# **CONNECTION ASSESSMENT & APPROVAL PROCESS**

*Project: MacKay TS - Replace breakers & disconnect switches*

***CAA ID No. 2002-EX050***

#### *Replace 115kV breakers & disconnect switches*

**DIAGRAM 1**

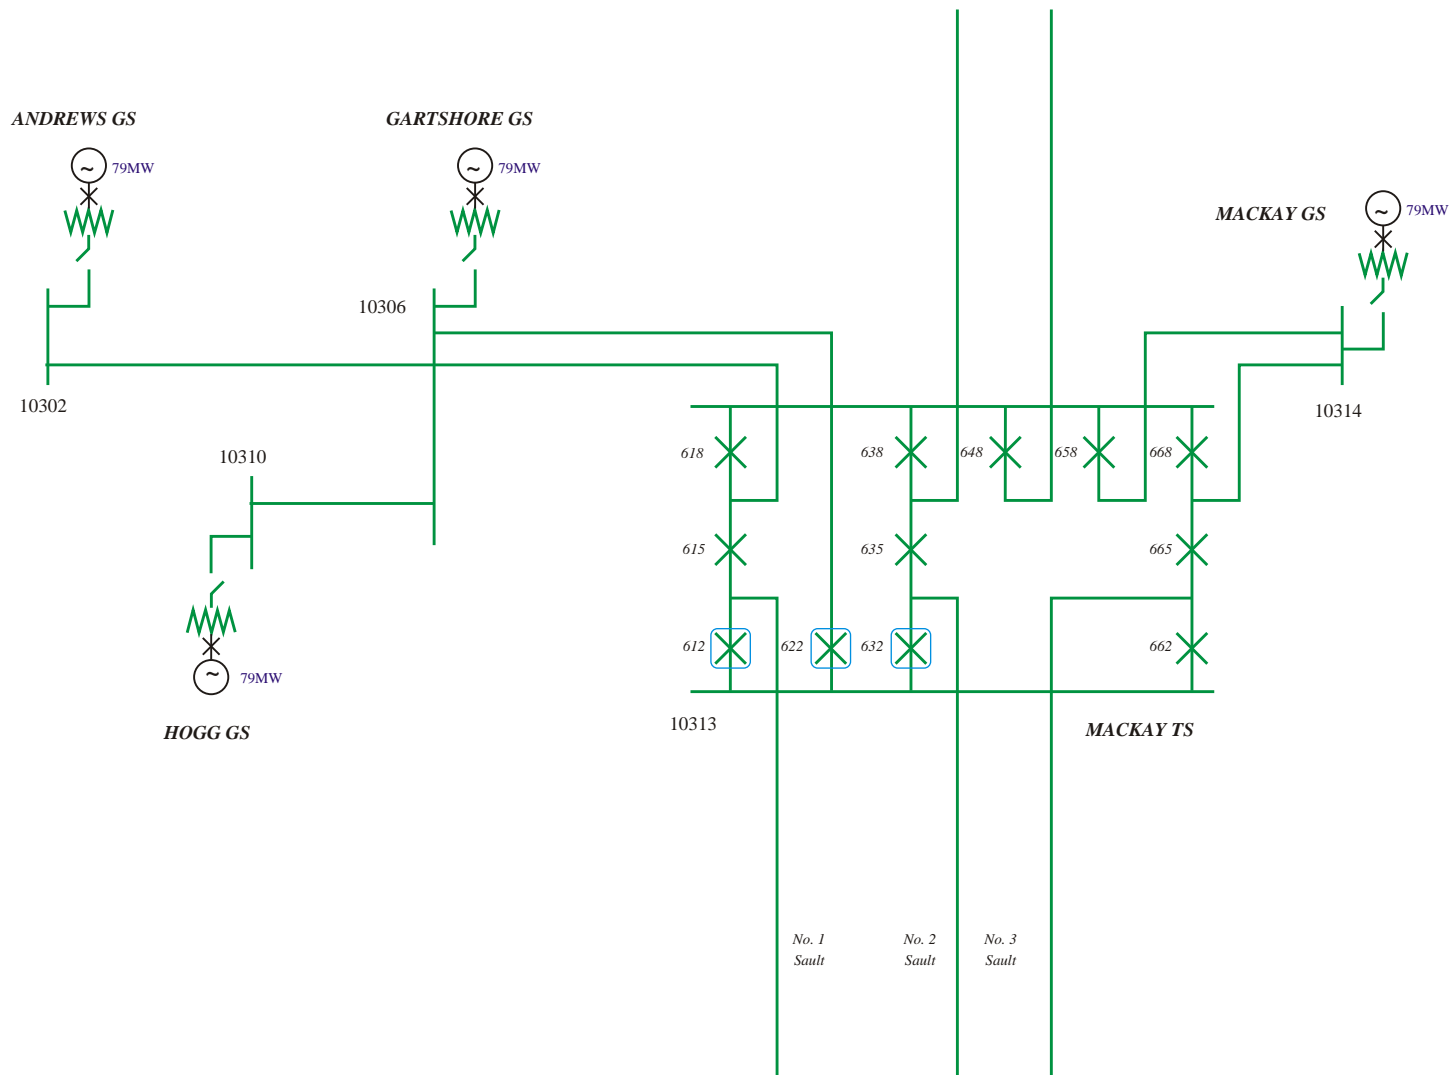
The facilities that are to be replaced are shown in Diagram 1.

It should be noted, however, that the three replacement breakers will not comply with the Transmission System Code that requires a rating of 50kA for new 115kV breakers.

While the 40kA rating of the new breakers is expected to be adequate for all foreseeable developments on the GLP system, should a third party initiate a development that would result in the fault level increasing above 40kA, then the subsequent replacement of these three breakers would be expected to be undertaken at Great Lake Power's expense.

It is therefore recommended that a Notification of Approval of the Connection Proposal be issued.
